Design Statement

10-16 Birdwood Avenue Cabramatta West.

1. Walkway Lighting, showing pelmet screen and recessed light

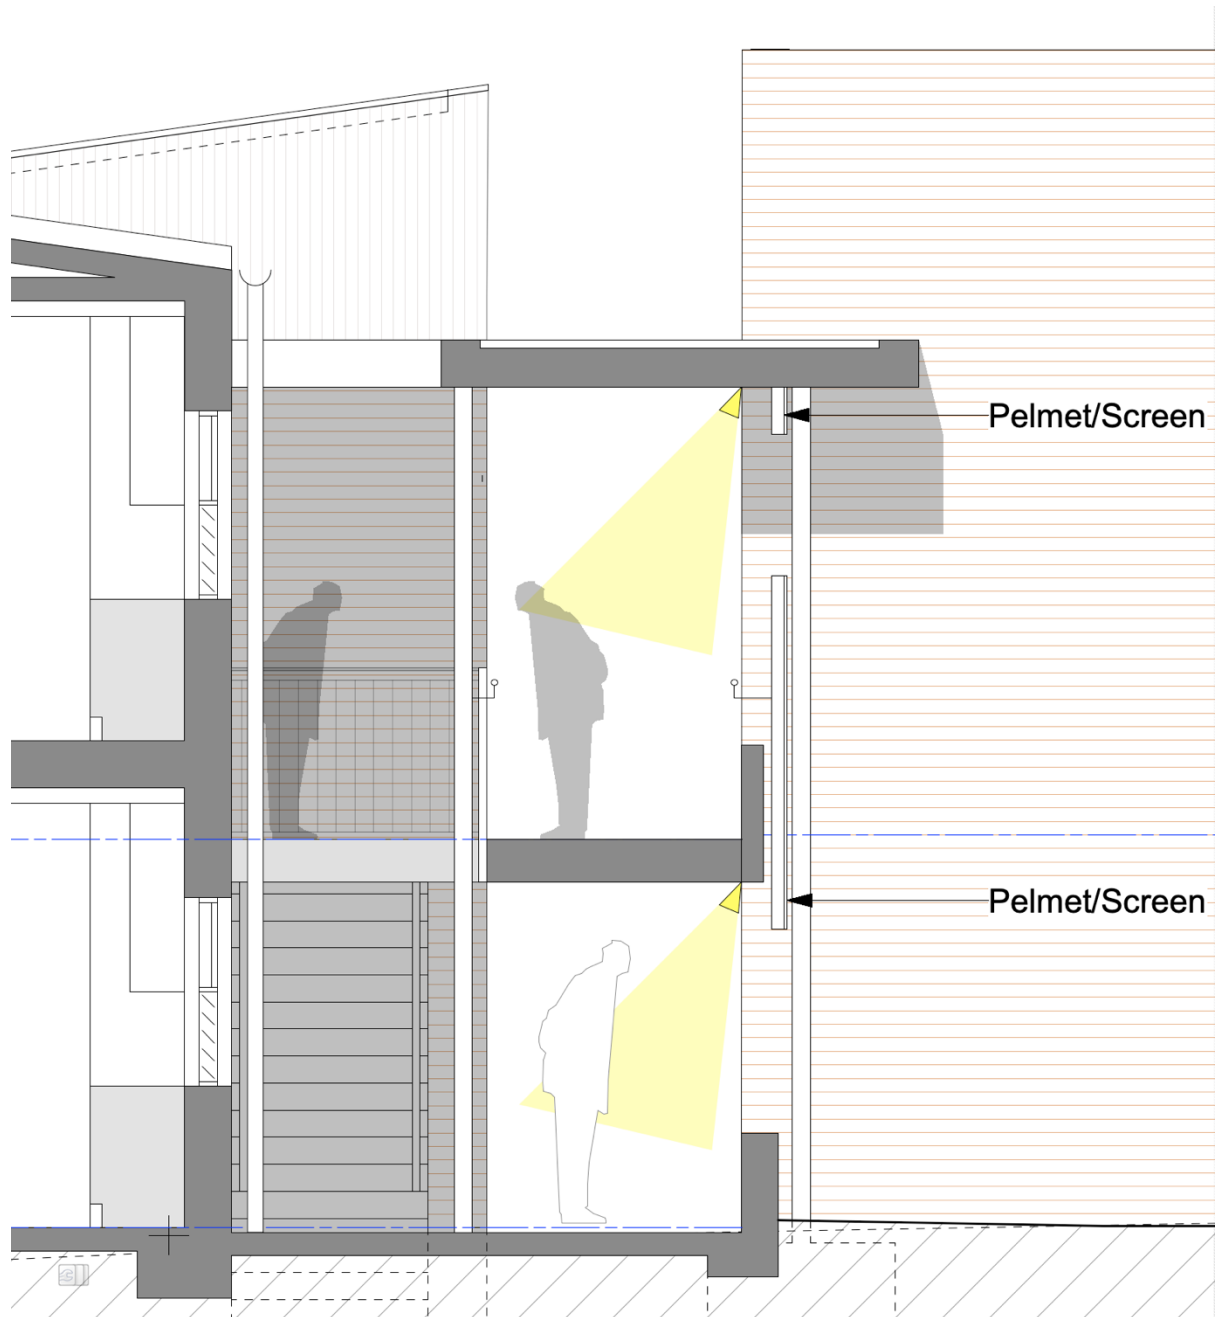
Walkway lighting can have a minimal impact to the neighbours with the following strategies;

- A screen/pelmet can be added to the level 1 walkway to contain any light spill. This screen can be in a matching perforated metal finish to the balustrade screen and so integrate with the walkway as a whole.
- The ground floor Lighting can be screened by extending the level 1 balustrade down another 300mm.
- These screens will contain and minimise light spill to the courtyard and the neighbours.
- The lights can be on a movement sensor and so will only be on intermittently
- See sketch attached on following page.
